Addendum No. 3

Bid / Request for Proposal Call No. T2024-220 Construction of the Fire station

This Addendum forms part of the Bid/Proposal Document.
(Question 1-95 had already been replied in Addendum 01 and 02)

2 SC-18 ELEVATION
1 : 50

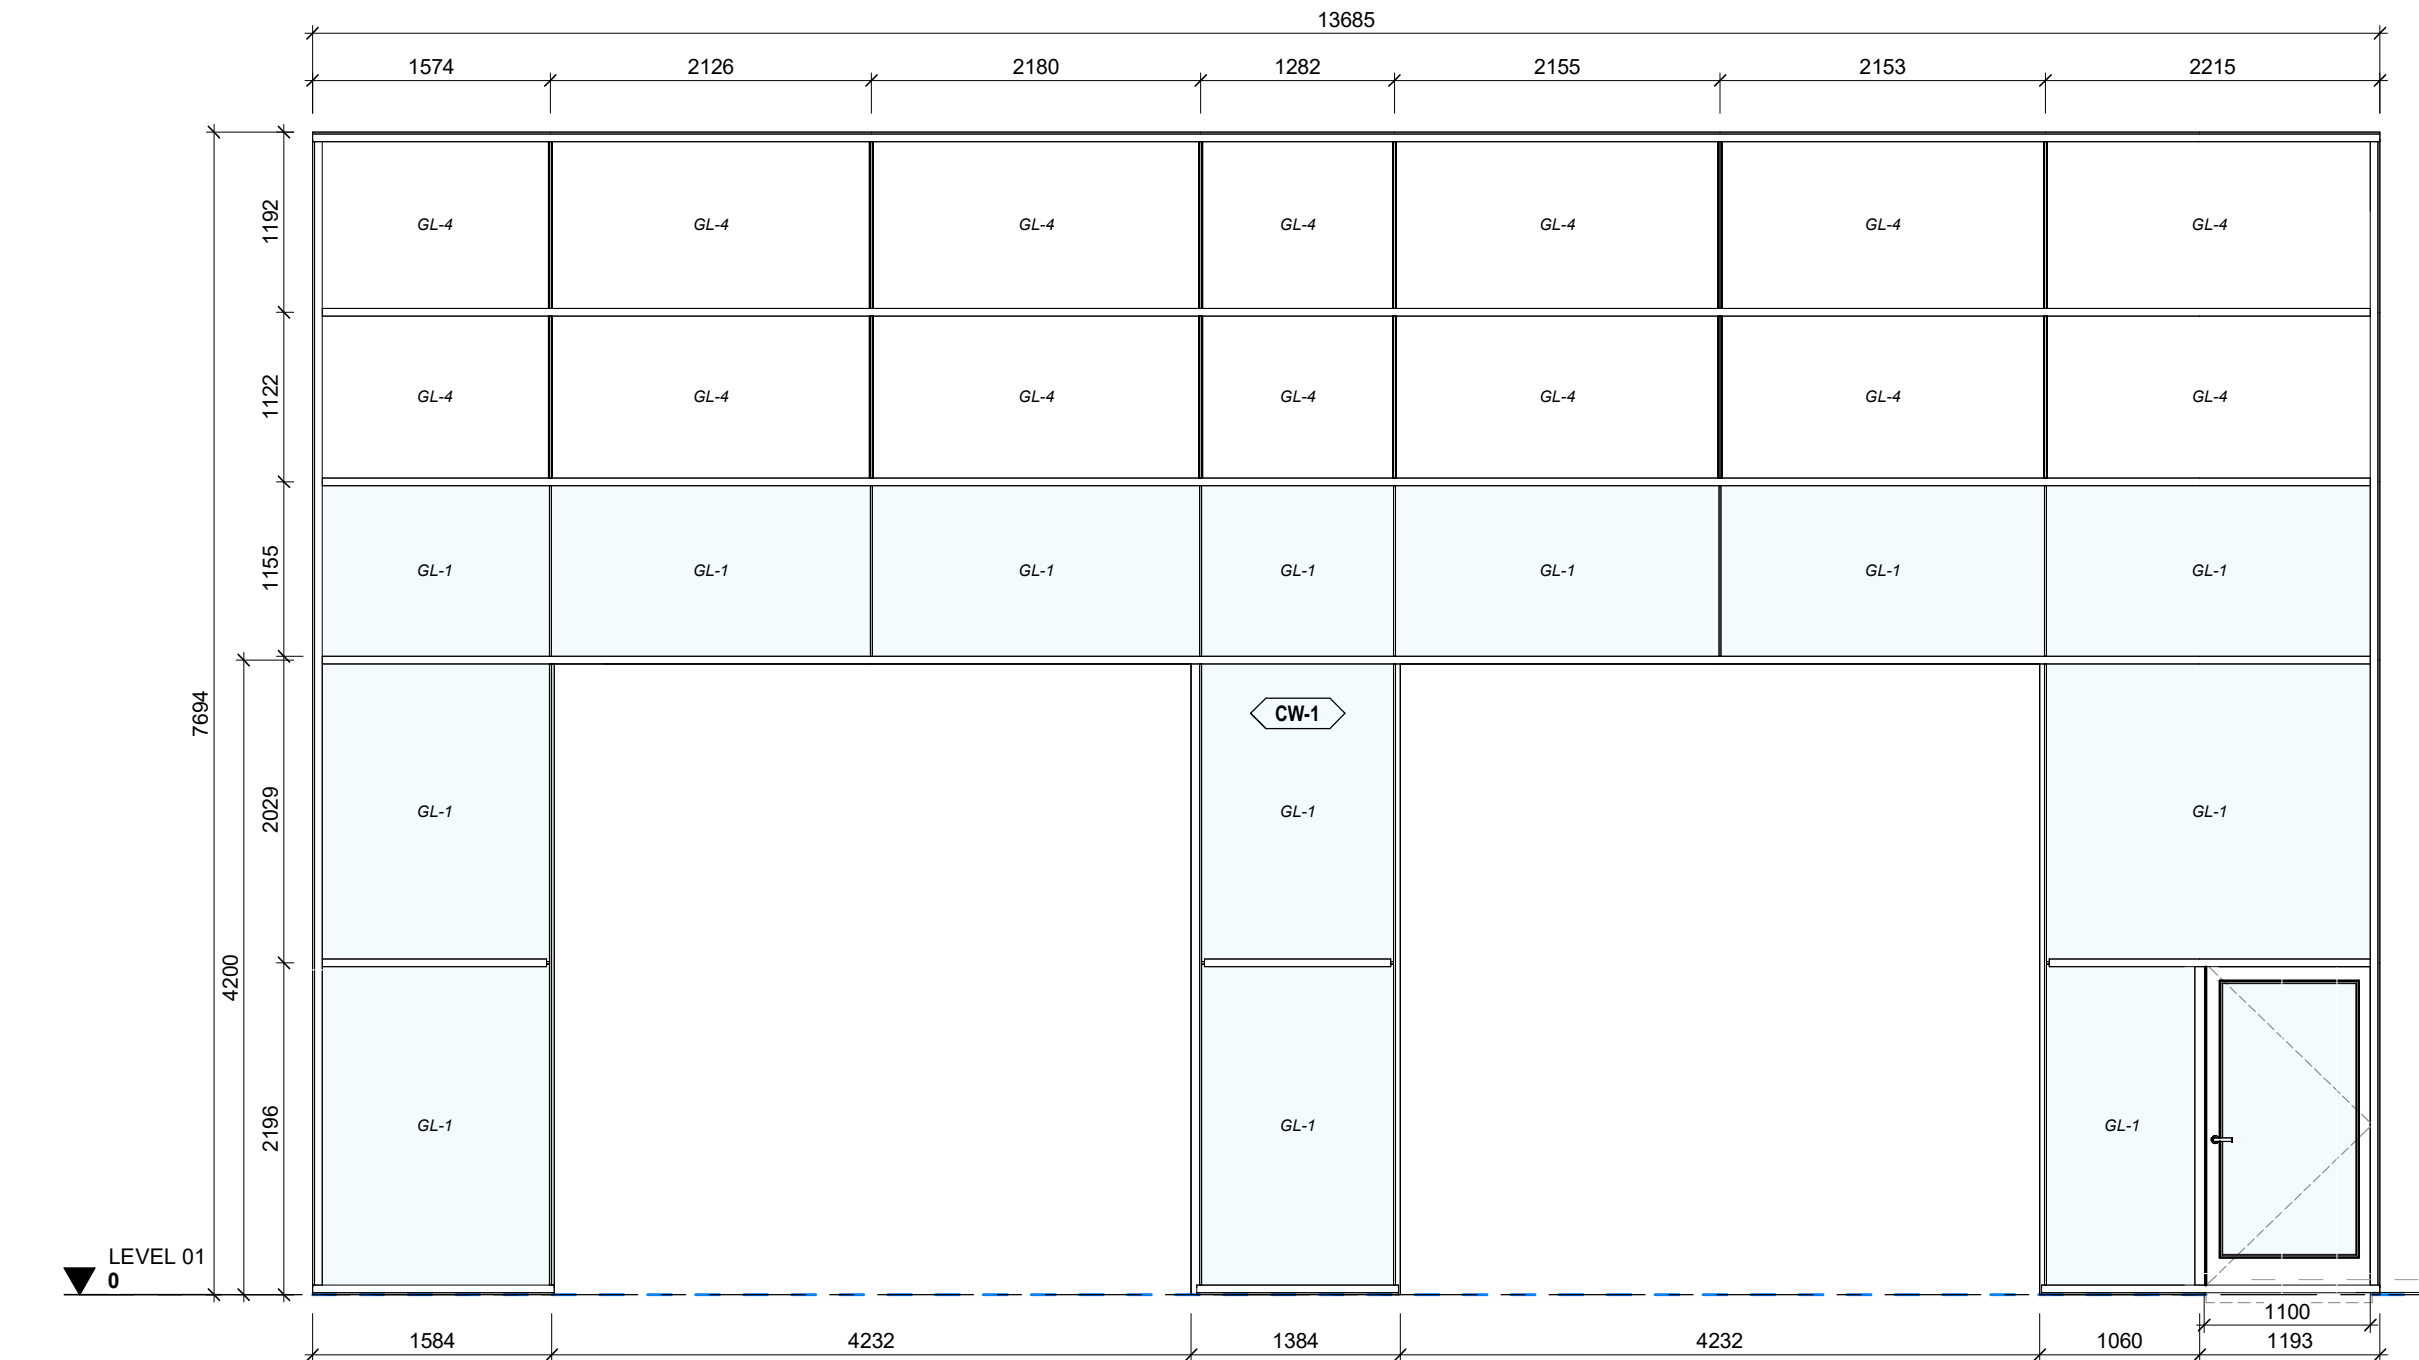
Some like SC-10 seem to be doubled up and SC 30 is not shown. The double up ones only have 1 on plans and elevations of the building so wondering what is going on here.

1. I am looking for more curtain wall plan and section details, I wanted to know if SC18 and SC20 have fastening points midway. 2inch frame might not pass wind load if there is none.
2. The curtain wall system was changed from Schuco to Alumicor TW2200, and A00.03 note is calling for an 8 inch back section. TW2200's deepest back section is 5inch, please confirm if we need to change to 2600 series.
3. Specs and some parts of the drawing calls for triple pane units, but window details on A07.03 shows a double glazed system. Please confirm if there is an intention to use double pane units in some areas and please identify which ones.
4. Are we supposed to supply GL4 - Solera -T R18 Glass for SC-18 and SC-20, the wall section looks like spandrel glass with a backpan. Can we use this as an alternative instead?

Drawing A06.01 and A06.02 have been revised to clarify glazing scope.

Drawing A06.01 and A06.02 have been revised to clarify glazing scope.

KEYNOTE LEGEND1	
Key Value	Keynote Text
ST	CONTRACTOR TO CARRY ROAD BEACONS AS CASH ALLOWANCE. REFER TO ARCHITECTURAL SPECIFICATIONS.

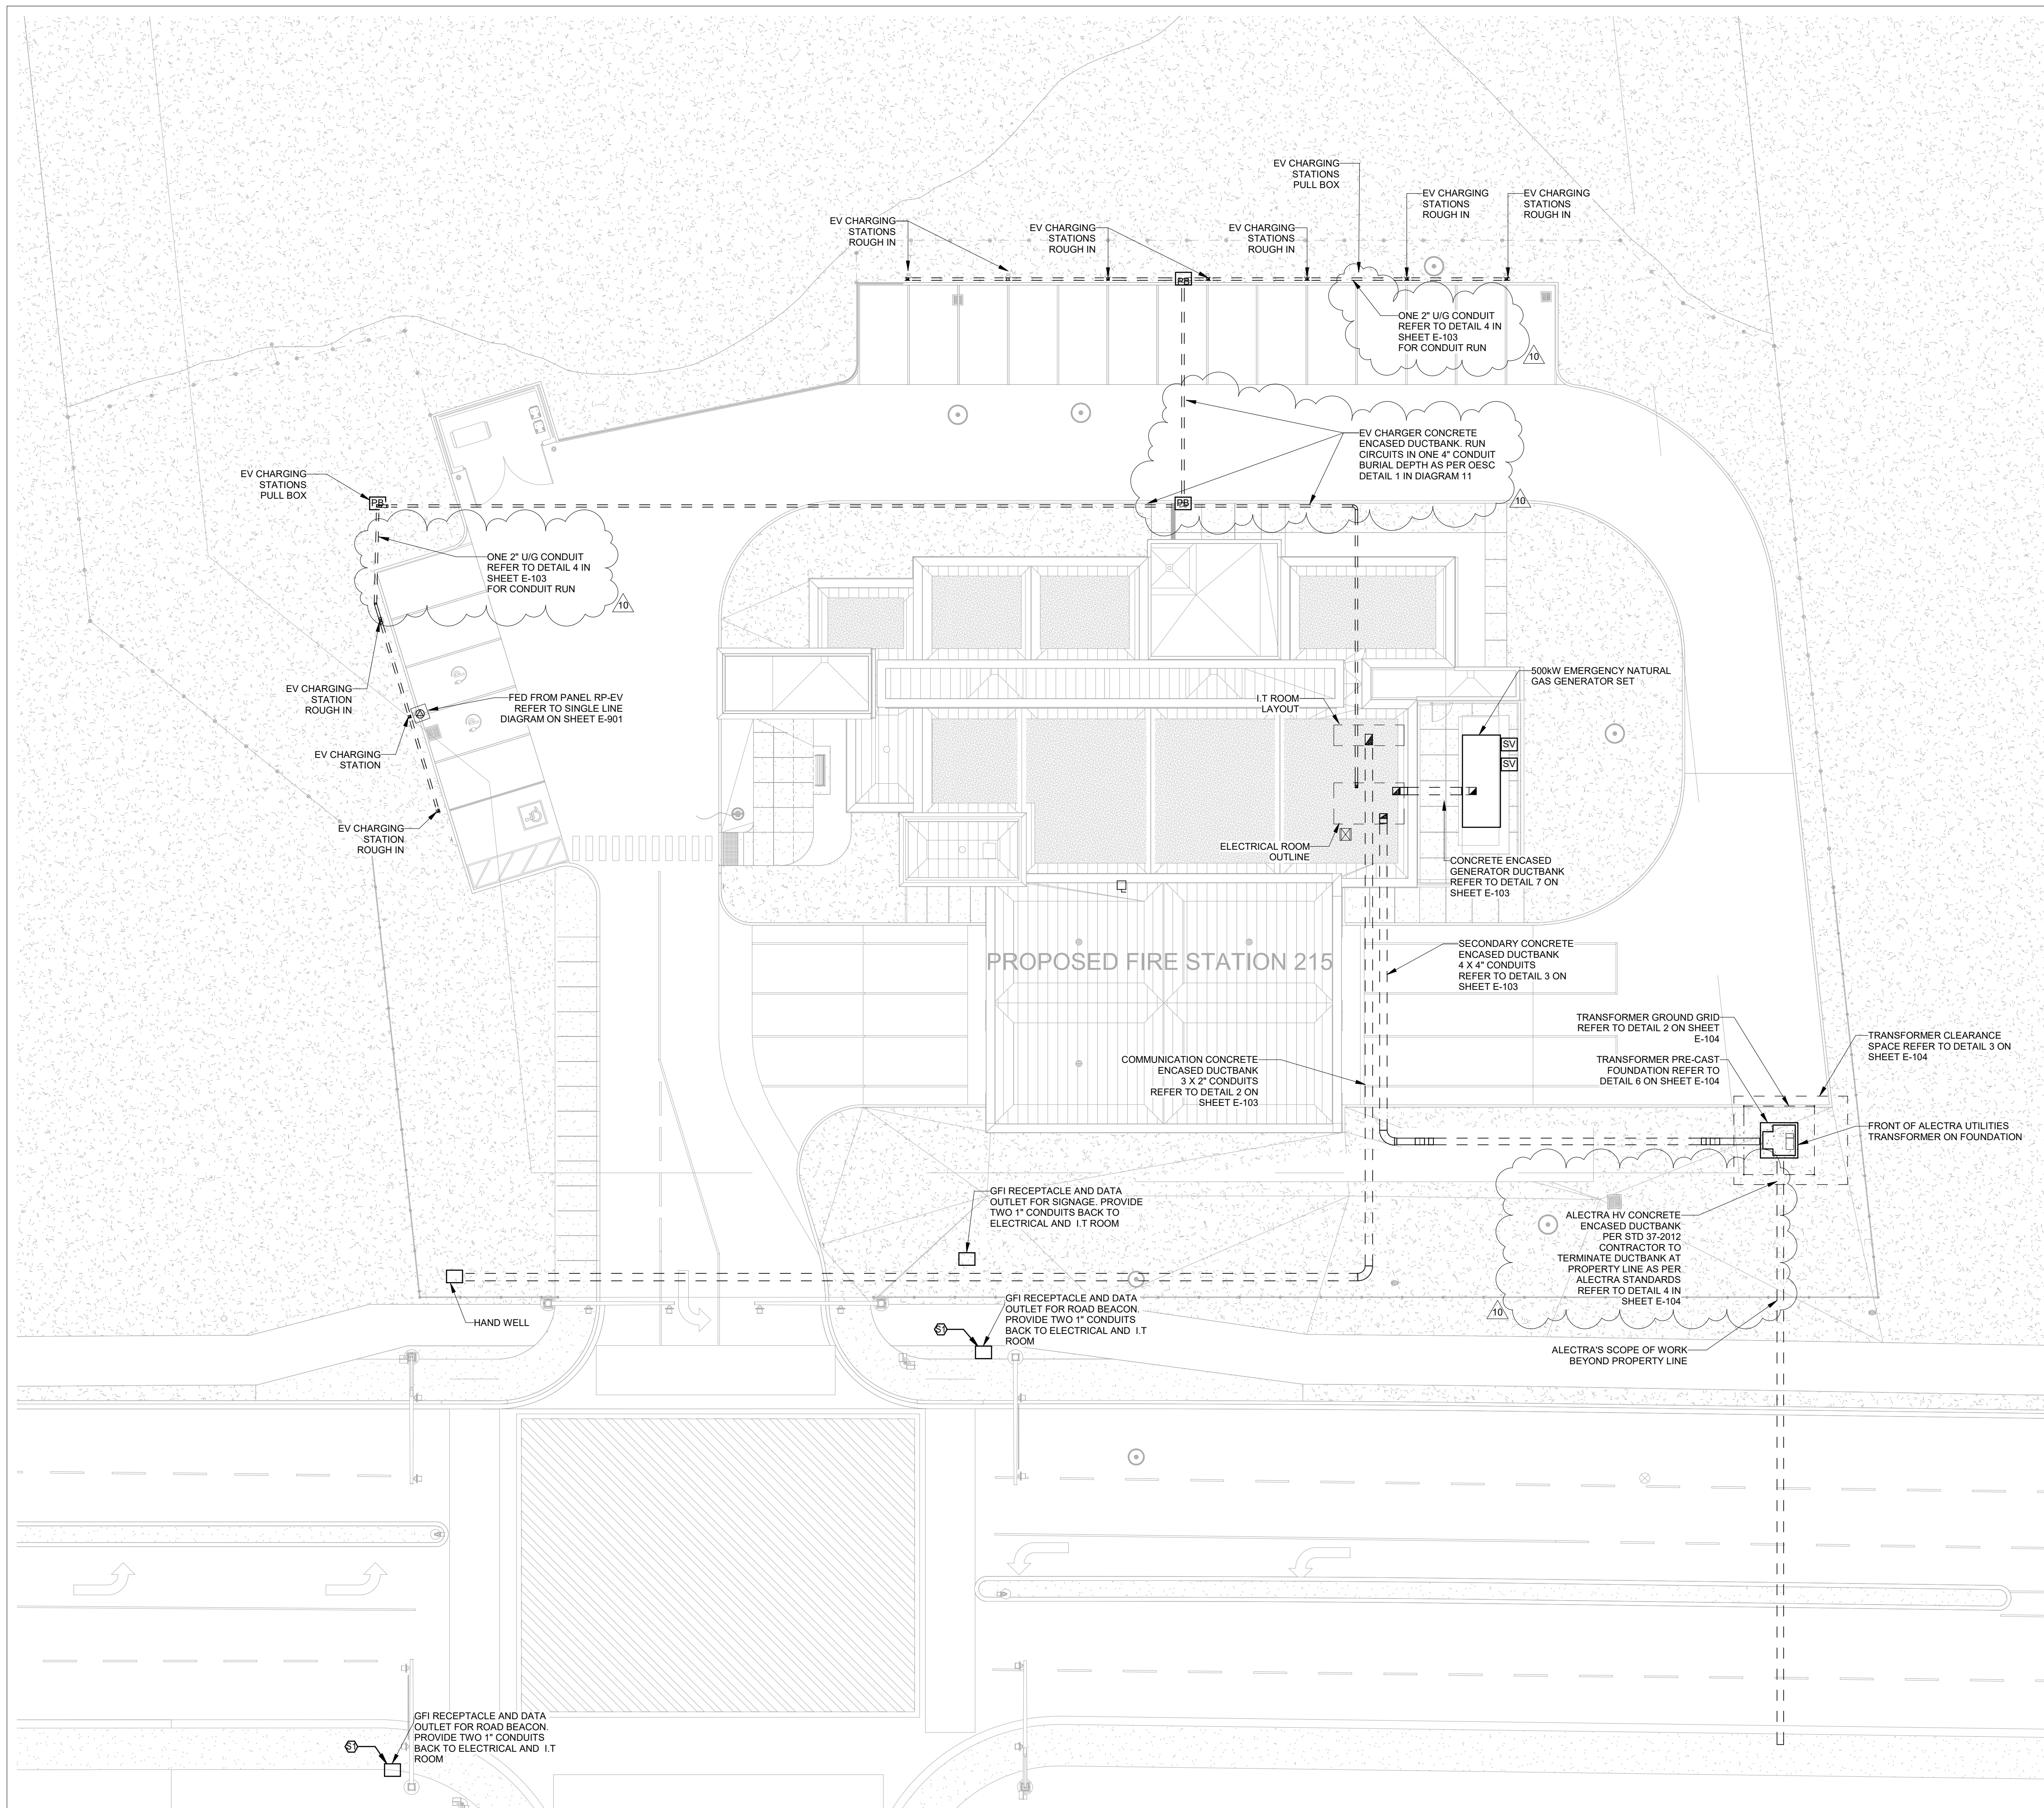
In regards to ADD#1 Q&A 79 (5), Please consider that all works associated with the road beacons be carried under cash allowance. We have no way of anticipating what the cost would be to provide trenching and rough in work to the beacons due to the road widening and infrastructure works and there may be concealed or unknown conditions that could cause delays or cost increases.
